UNITED STATES
DEPARTMENT OF THE INTERIOR
BUREAU OF LAND MANAGEMENTFORM APPROVED
OMB NO. 1004-0137
Expires: January 31, 2018**SUNDRY NOTICES AND REPORTS ON WELLS**
Do not use this form for proposals to drill or to re-enter an abandoned well. Use form 3160-3 (APD) for such proposals.5. Lease Serial No.
NMNM94651

OXY USA Inc. respectfully requests the following bulk sundry changes to the approved APD's for the following wells:

1. Salt Flat CC 20-29 Federal Com #37H - 30-015-46369
2. Salt Flat CC 20-29 Federal Com #38H - 30-015-46399

OXY USA Inc. – Salt Flat CC 20-29 Federal Com 37H-38H – Amended Drill Plan

General well schematic:

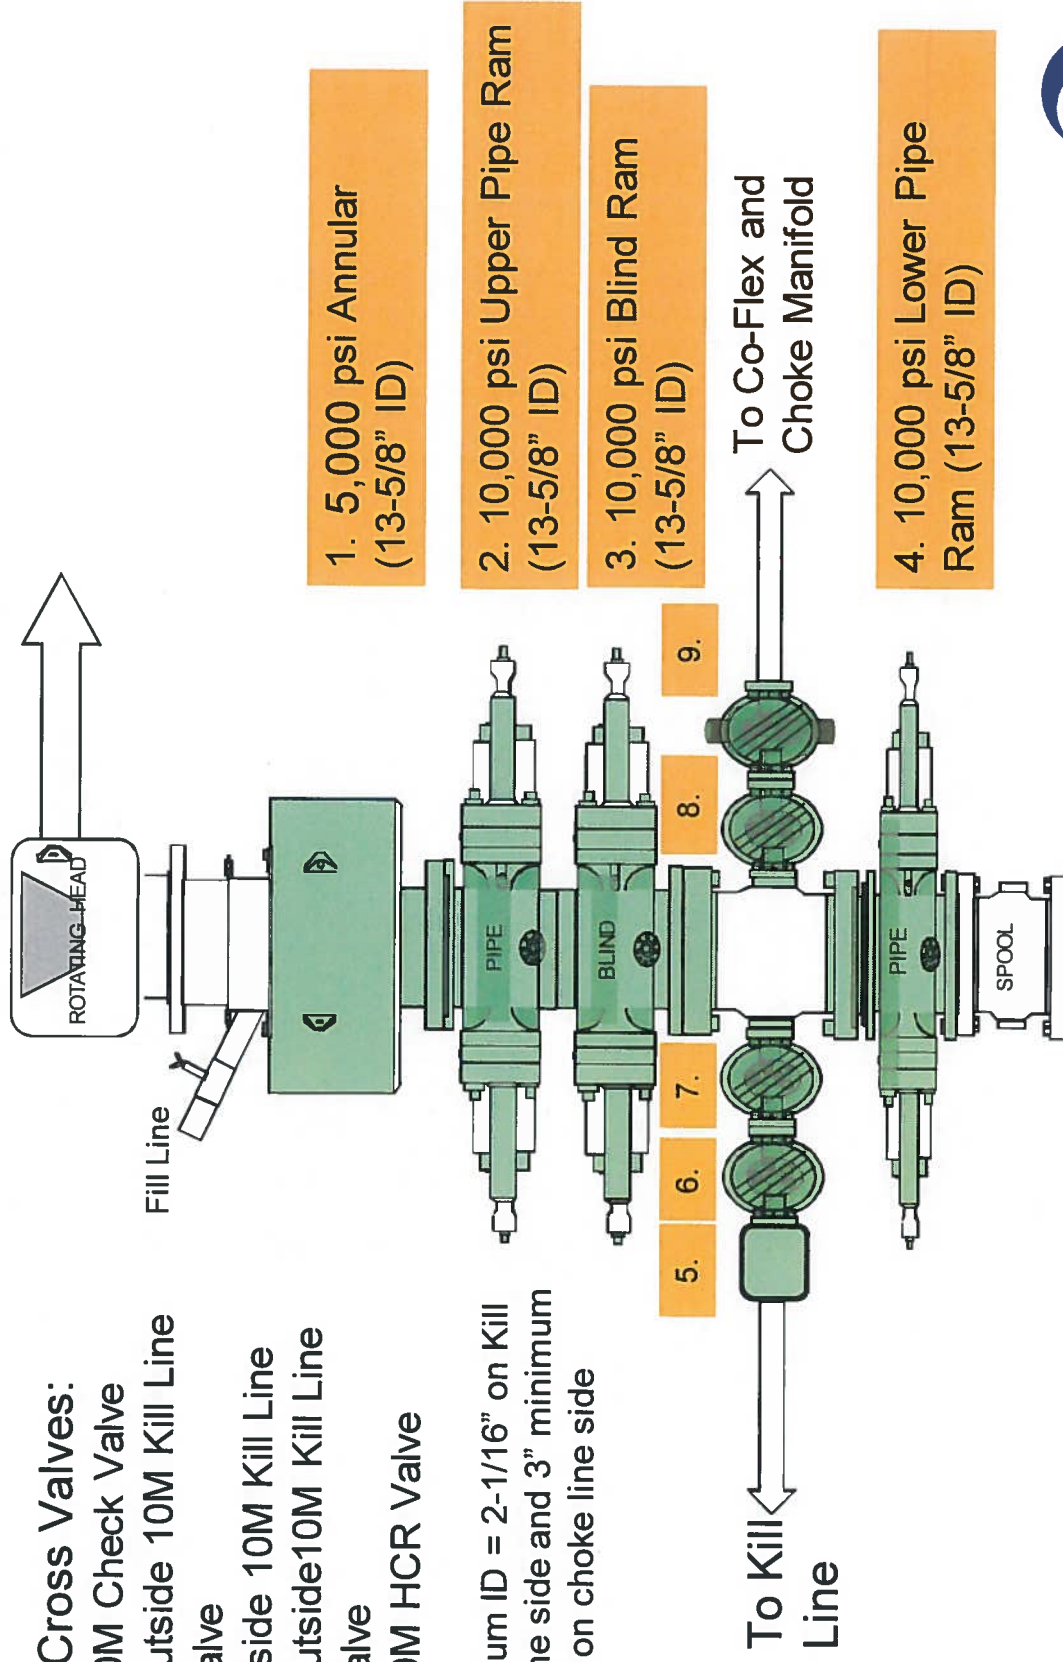
1. Change Production Casing to Liner and update cementing information. See attached for Casing Tie Back Detail

1. OXY is requesting permission to have minimum fill of cement behind the 5-1/2” production liner to be 100’ into previous casing string. The reason for this is so that we can come back and develop shallower benches from the same 7-5/8” mainbore in the future.
2. Our plan is to use a whipstock for our exit through the mainbore. Based on our lateral target, we are planning a whipstock cased/hole exit so that kick-off point will allow for roughly 10deg/100’ doglegs needed for the curve.
3. Cement will be brought to the top of this liner hanger.
4. See attached for additional casing tie-back information.

- Drill 17-1/2" hole x 13-3/8" casing for surface section. Cement to surface.
- Drill 9-7/8" hole x 7-5/8" casing for intermediate section. Cement to surface.
- Drill 6-3/4" hole x 5-1/2" liner for production section. Cement to top of liner, 100' inside 7-5/8" shoe.
- Release drilling rig from location.
- Move in workover rig and run a 5-1/2" 20# P110 DQX tie-back frack string and seal assembly (see connection specs below). Tie into liner hanger Polished Bore Receptacle (PBR) with seal assembly.
- Pump hydraulic fracture job.
- Flowback and produce well.

5/10M BOP Stack

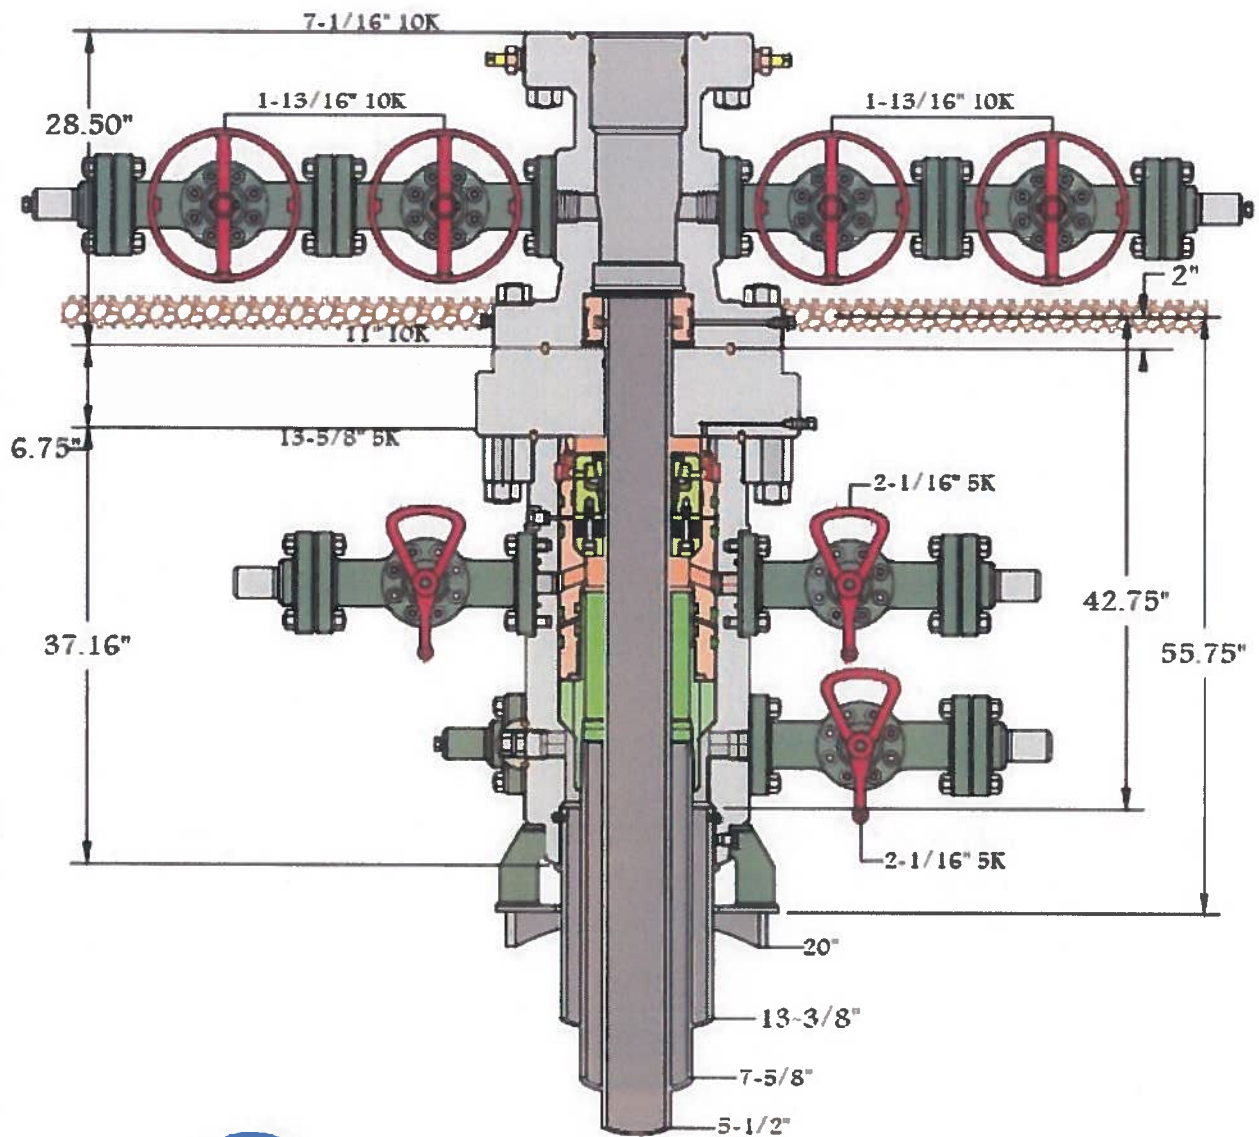
- 2. Request Bradenhead squeeze for the 2nd stage Intermediate casing with the Bradenhead CBL requirement.
- 3. Request Offline Intermediate Casing/Cementing Variance, see attached.
- 4. Update BOP Break Testing Request, Information and Plan
- 5. Update BOP/Wellhead Diagram

Oxy will utilize a 5M annular with a 10M BOPE stack. The BOP/BOPE will be tested by an independent service company to 250 psi low and the high pressure indicated above per Onshore Order 2 requirements. The System may be upgraded to a higher pressure but still tested to the working pressure listed in the table above. If the system is upgraded all the components installed will be functional and tested.
